Location Address: 1225 N17th CT

Explanation of Request: SITE PLAN APPROVAL OF A 15 UNIT RESIDENTIAL DEVELOPMENT

PRELIMINARY TAC RESPONSE TO COMMENTS

ARTHUR STREET APARTMENTS
1225 N 17th CT
HOLLYWOOD, FL 33020

EROSION & SEDIMENT CONTROL PLAN

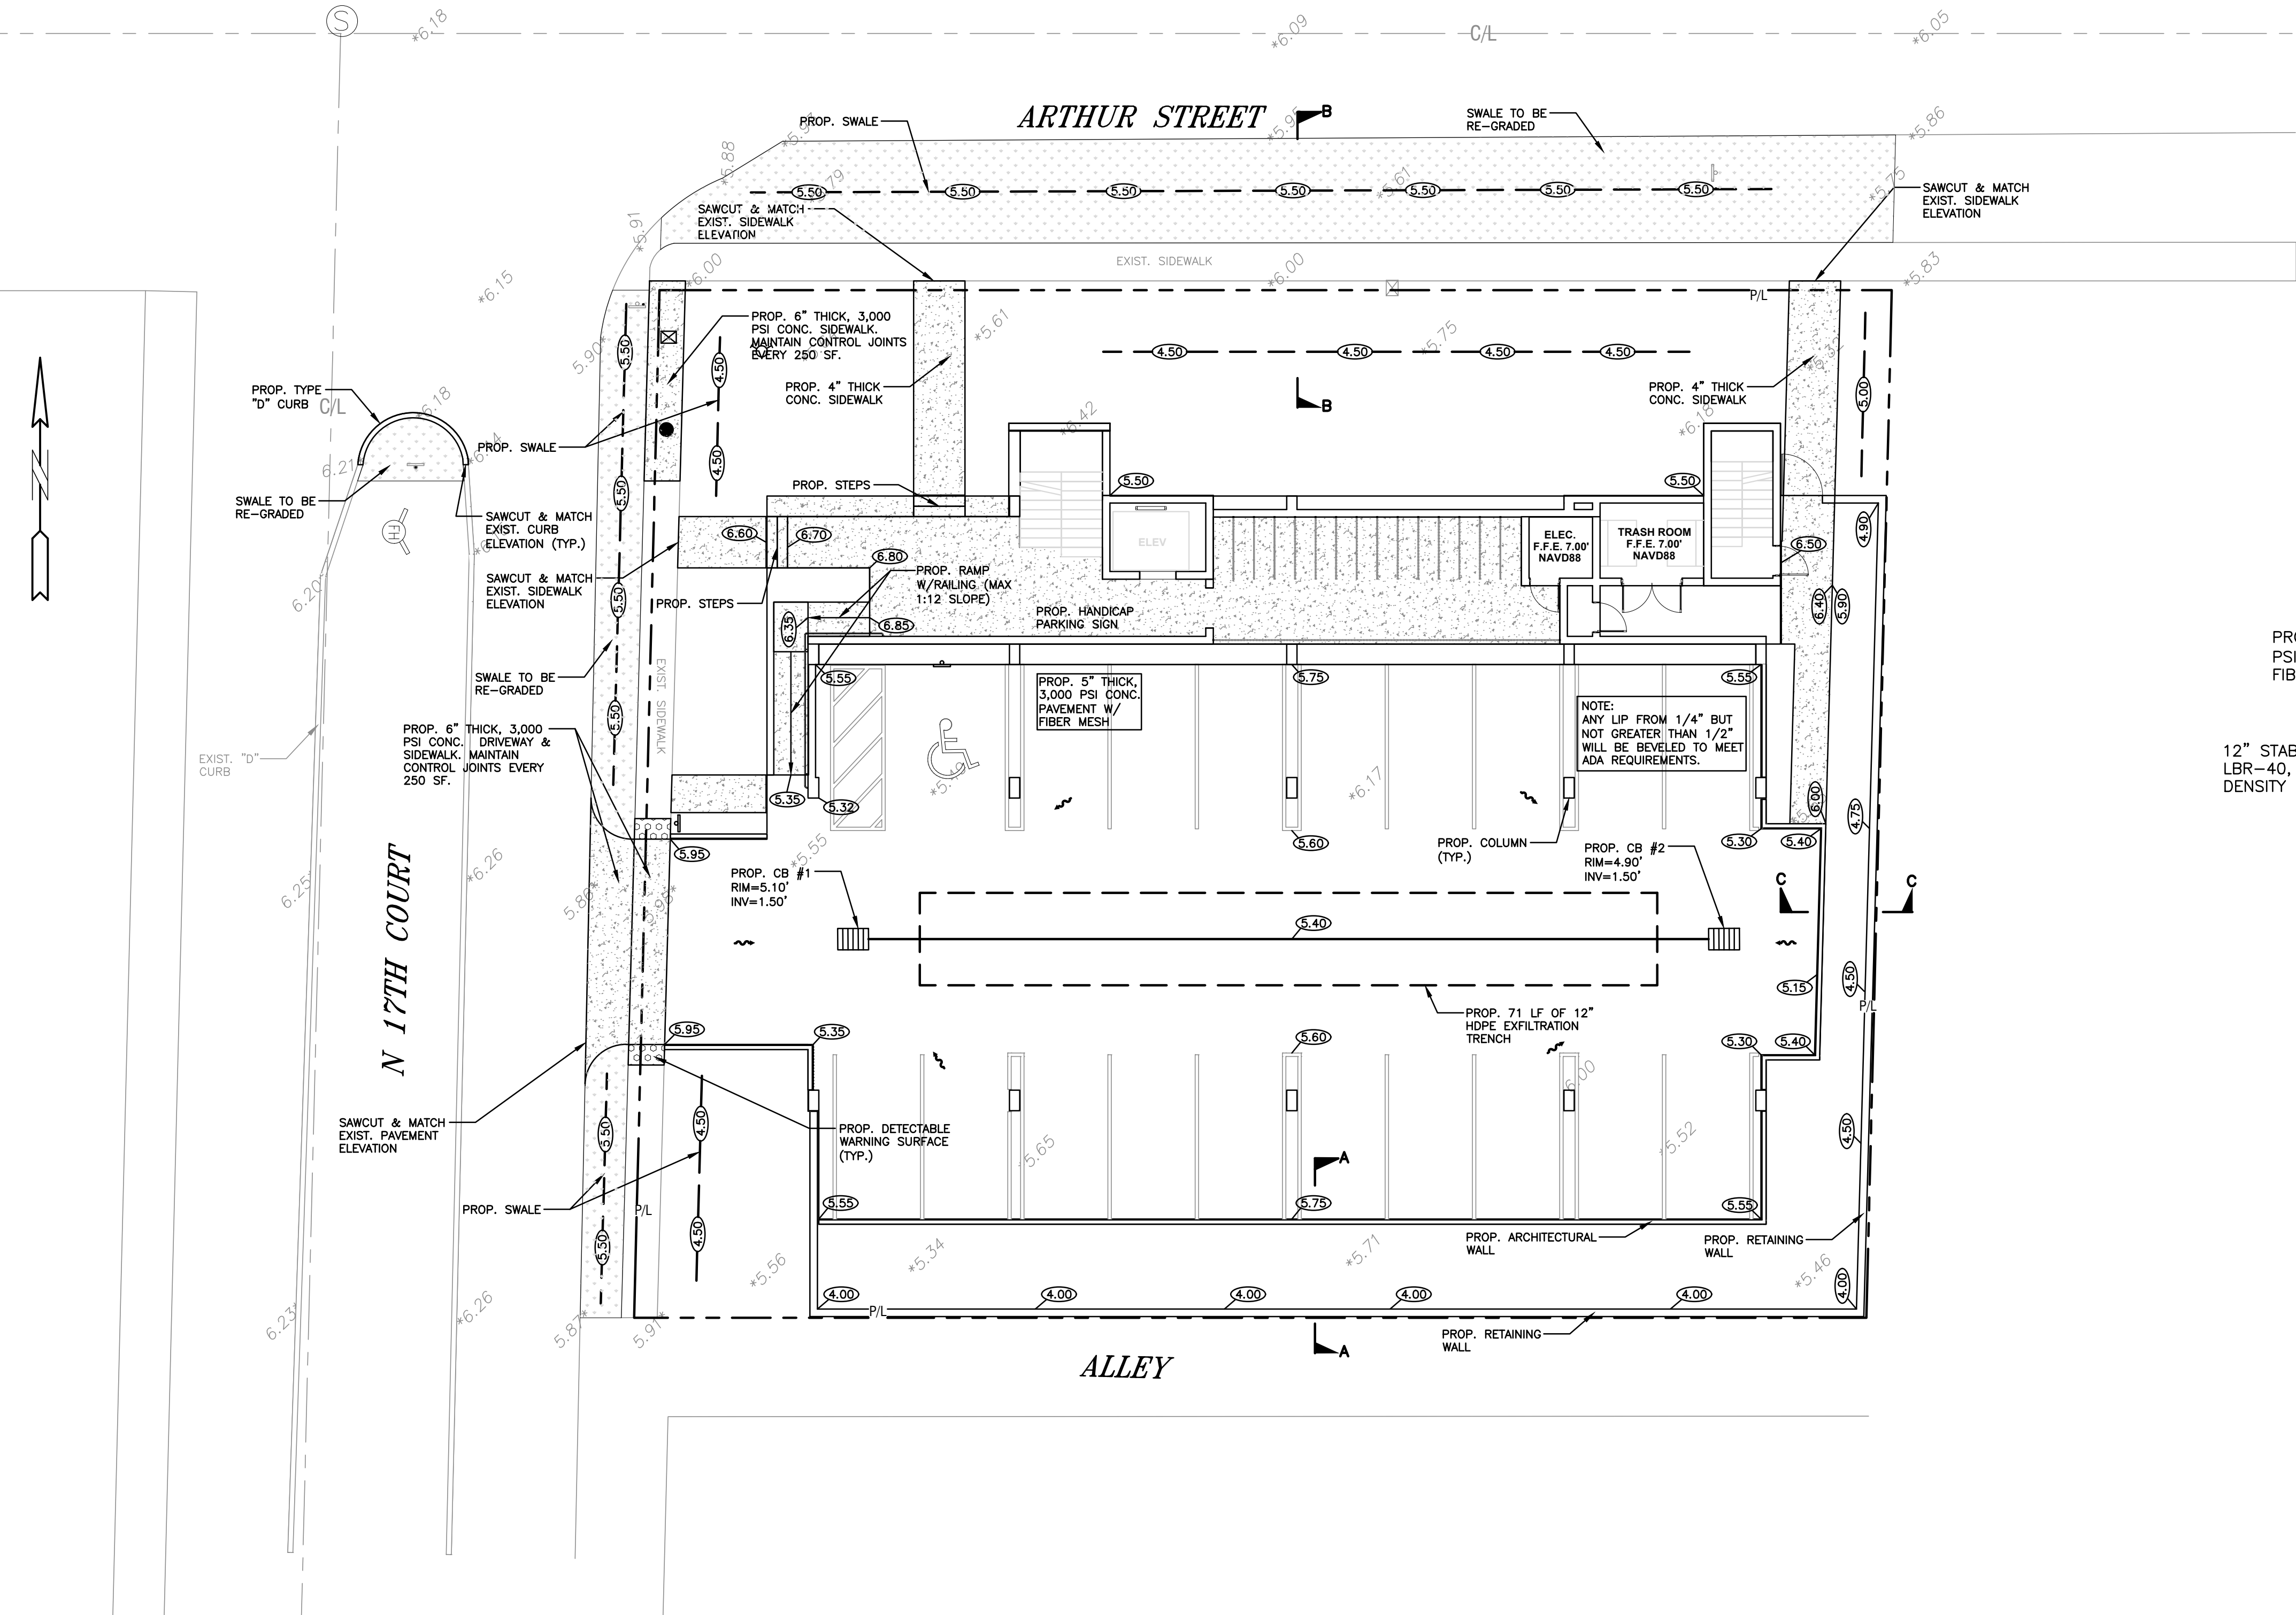
11. Include erosion control plan.

RESPONSE: See Erosion Control Plan, Sheet C-1.

SECTION A-A
N.T.S.

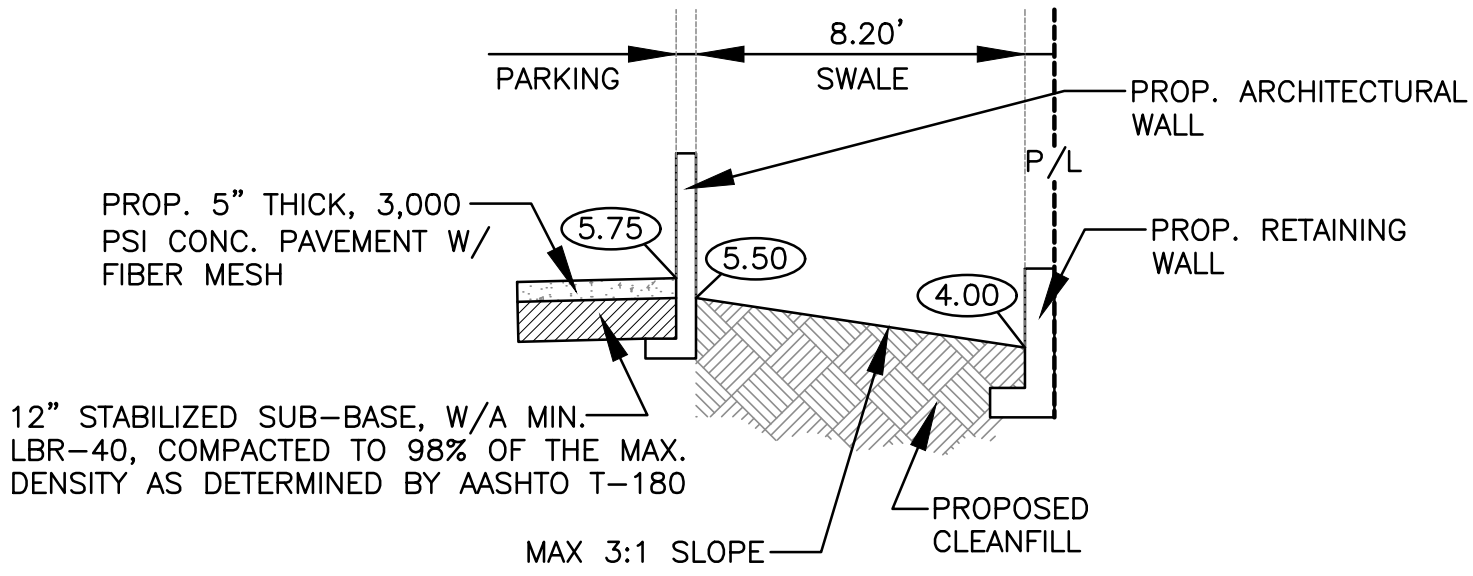
RESPONSE: All BOH Areas dimensioned as requested.
26. Please label the stair, Stair #1 and Stair #2.
RESPONSE: Stair 01 and Stair 02 labelled.
27. Elevations show for a 6' Solid White Fence surrounding the site. Please show the fence on the Site Plan. No portion of the fence/gate or footers are to encroach beyond the property lines, into adjacent property or City ROW. Provide dimension for minimum setback of the fence on the Site Plan to accommodate the footers/fence. Cross section of the fence with footer showing the setback from the property line will be required at the time of permit review.

RESPONSE: Solid white fence and all related footing will be within property lines. See sheet A001 and Section A-A on civil sheet C-2
28. Provide civil plans for the proposed project. Indicate items such as but not limited to drainage improvements, curbing, drive aisle widths, vehicular circulation, sight visibility triangle, vehicular turning radii, pavement marking and signage plans and details. Show location of existing water and sewer mains on plans and show the project is planning to connect to the city system. For water and sanitary sewer connection, show any pavement restoration and details required for

1 PLANTING PLAN
1/8" = 1'-0"

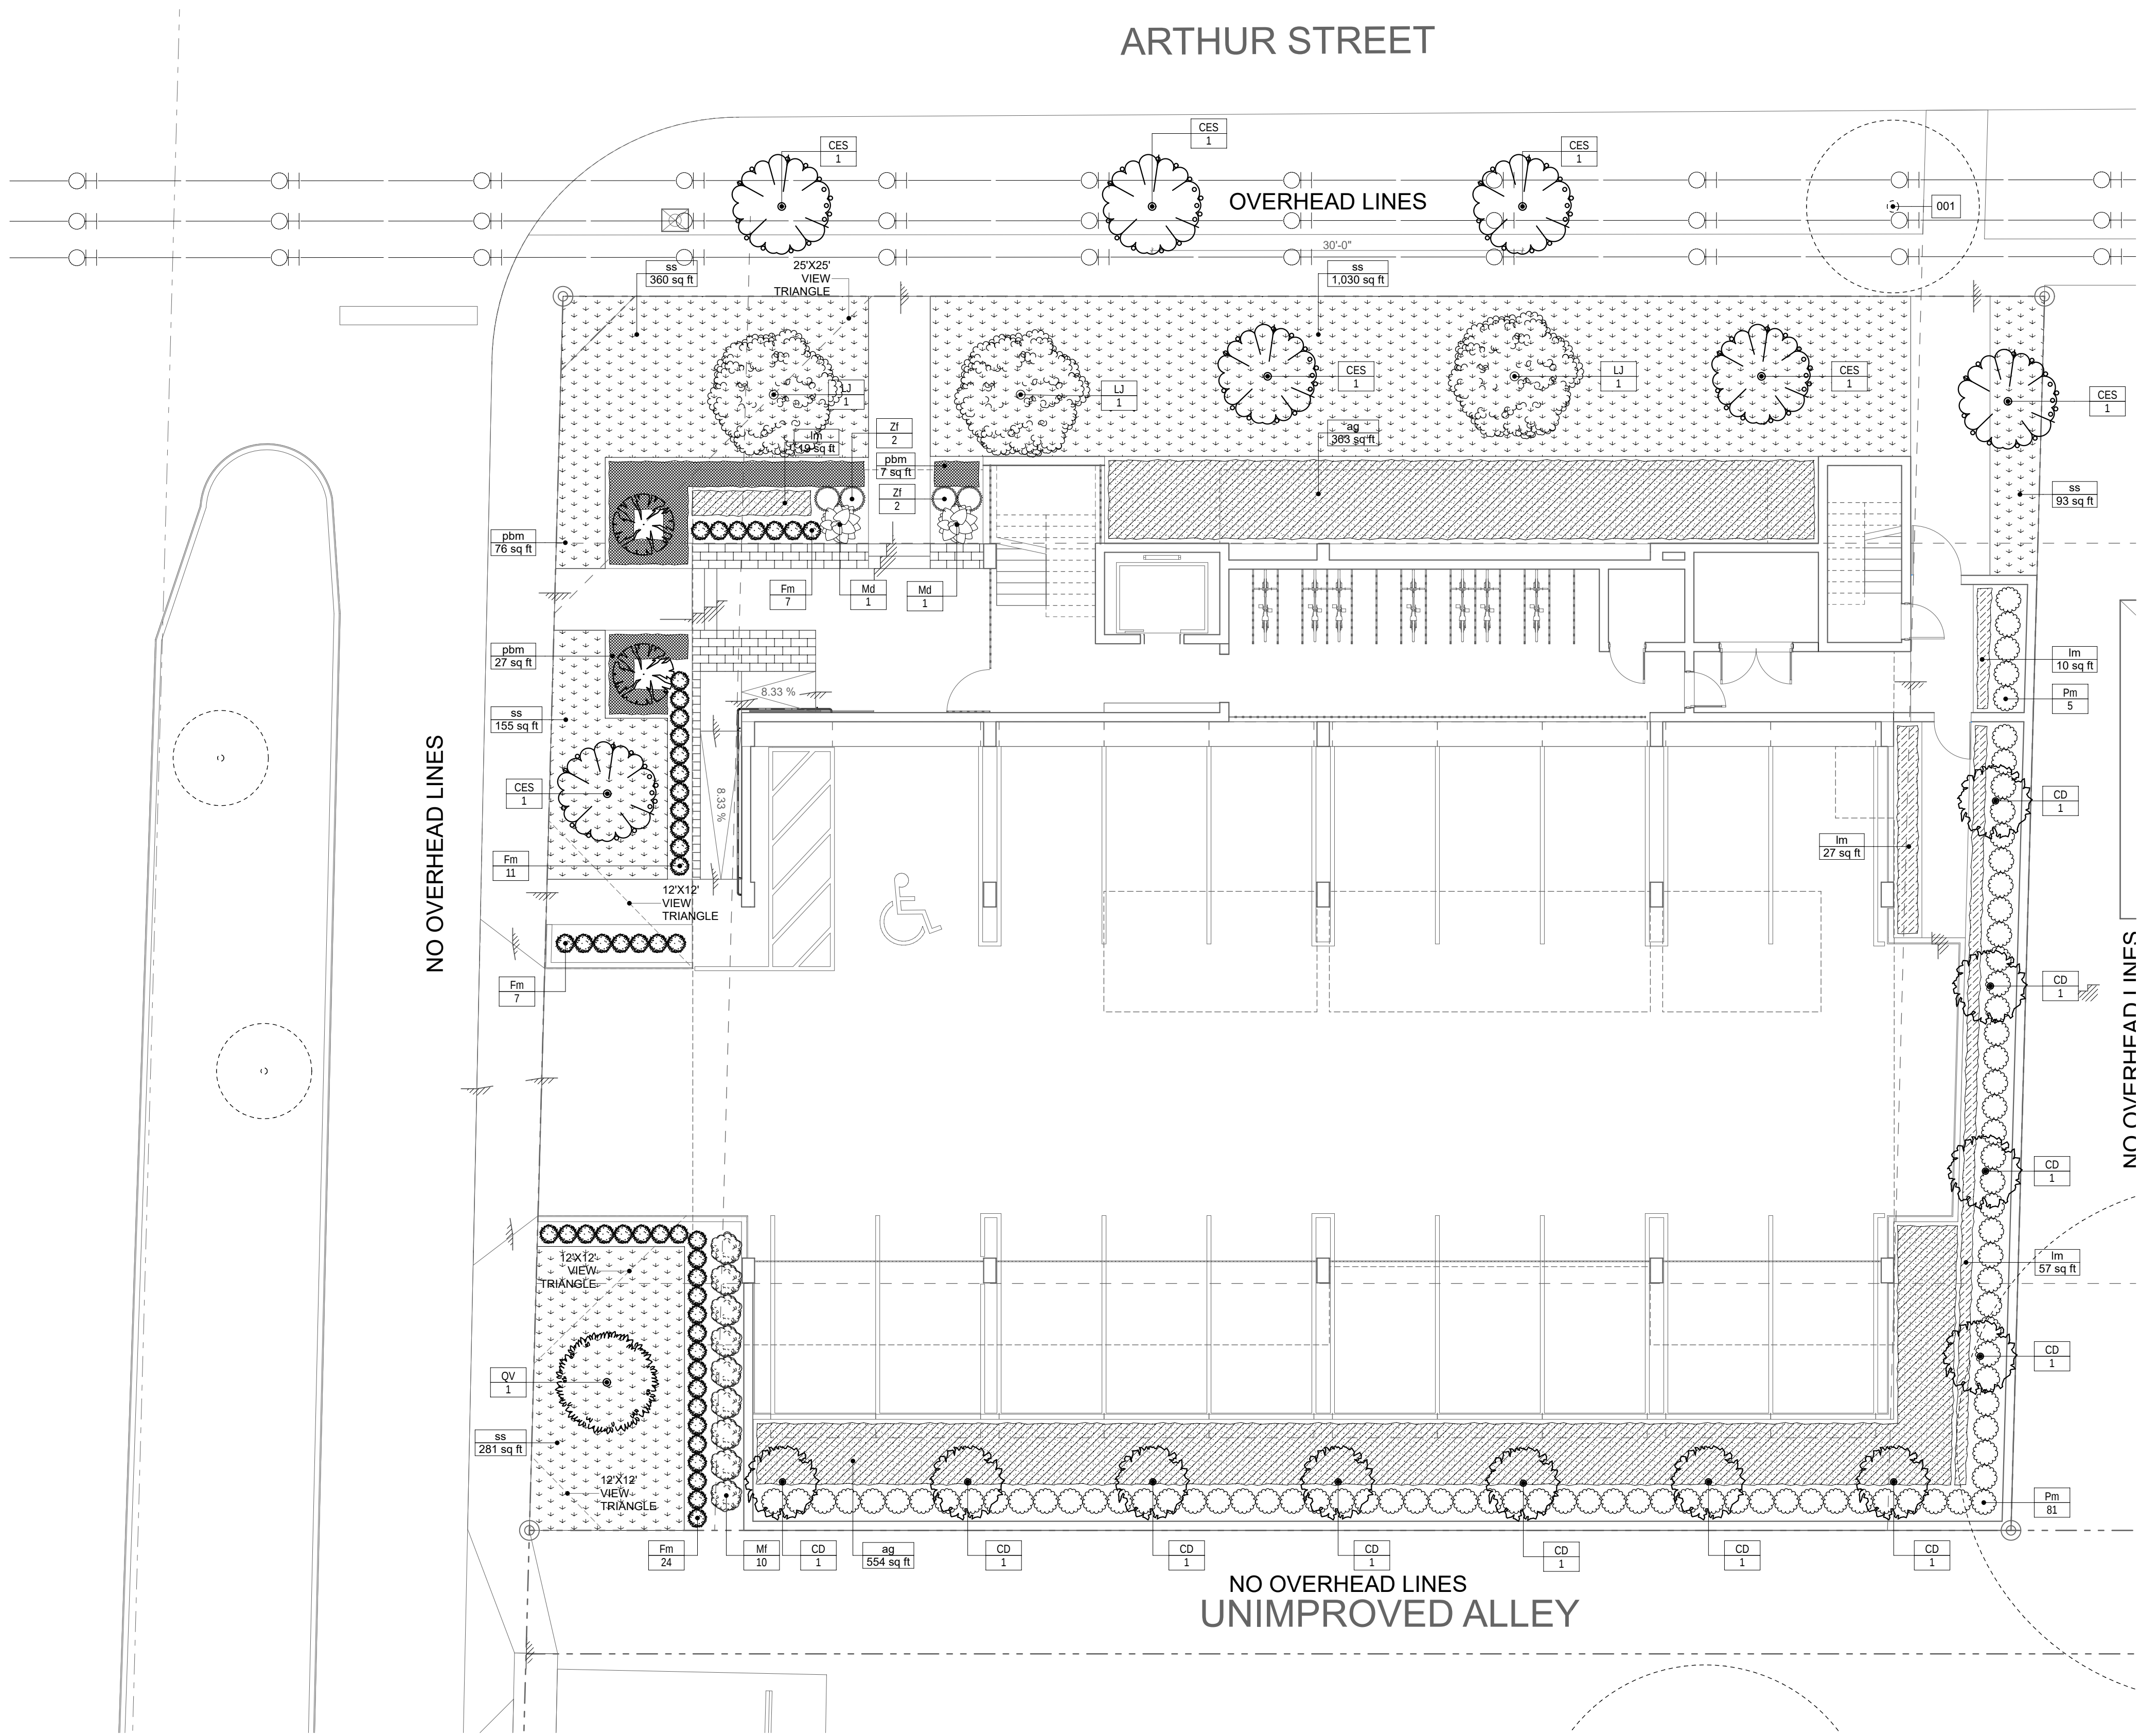
4. Provide sight triangles on plans at intersection of driveway and property line – Sec. 155.12 (d)

5. Native plant requirements; 60% trees, 50% shrubs – Sec. 3.4.

11. 11. Provide note indicating: 100% irrigation coverage shall be provided.

RESPONSE: All site triangles noted on sheet L200

RESPONSE: Native plant species requirements indicated on sheet L200

RESPONSE: Irrigation note provided. See sheet L200.
